#### AFFIDAVIT OF CORRECTION

To correct certain dimensions and bearings of North Lake Hills Addition, Final Plat, in the SW 1/4 of Section 23, Township 16 North, Range 12 East of the 6th P. M., Douglas County, Nebraska.

## AFFIDAVIT OF CORRECTION

# AFFIDAVIT OF CORRECTION

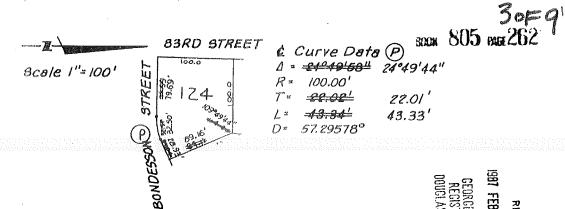
The Westerly bearing of North Lake Hills Addition to read N00°17'36"W instead of N2°28'16.0"W. The Northwesterly bearing of North Lake Hills Addition to read N44'49'24"E instead of N42°49'20.6"E. The Northwesterly dimension of North Lake Hills Addition to read 928.42 feet instead of 929.33 feet. The Northerly bearing of North Lake Hills Addition to read S00°13'25"E instead of N87°39'23.0°E. The Easterly bearing of North Lake Hills Addition to read S00°13'25"E instead of S2°22'08.2"E. The Southerly bearing of North Lake Hills Addition to read S64°52'44"W instead of S62°41'46"W. The Southerly dimension of North Lake Hills Addition to read S70°35'23"W instead of S68°24'24"W. The Southerly bearing of North Lake Hills Addition to read S70°35'23"W instead of S68°24'24"W. The Southerly dimension of North Lake Hills Addition to read 100.48 feet instead of 100.50 feet. The Southerly dimension of North Lake Hills Addition to read S64°52'40"W instead of S56°59'08"W. The Southerly bearing of North Lake Hills Addition to read S59°09'59"W instead of S56°59'08"W. The Southerly bearing of North Lake Hills Addition to read S59°09'59"W instead of S62°41'46"W. The Southerly bearing of North Lake Hills Addition to read S64°52'39"W instead of S62°41'46"W. The Southerly dimension of North Lake Hills Addition to read S70°42'24"W instead of S62°41'46"W. The Southerly dimension of North Lake Hills Addition to read S70°42'24"W instead of S62°41'46"W. The Southerly dimension of North Lake Hills Addition to read S70°42'24"W instead of S68°31'23"W. The Southerly dimension of North Lake Hills Addition to read S70°42'24"W instead of S68°31'23"W. The Southerly dimension of North Lake Hills Addition to read S70°42'24"W instead of S68°31'23"W. The Southerly dimension of North Lake Hills Addition to read S70°42'24"W instead of S68°31'23"W.
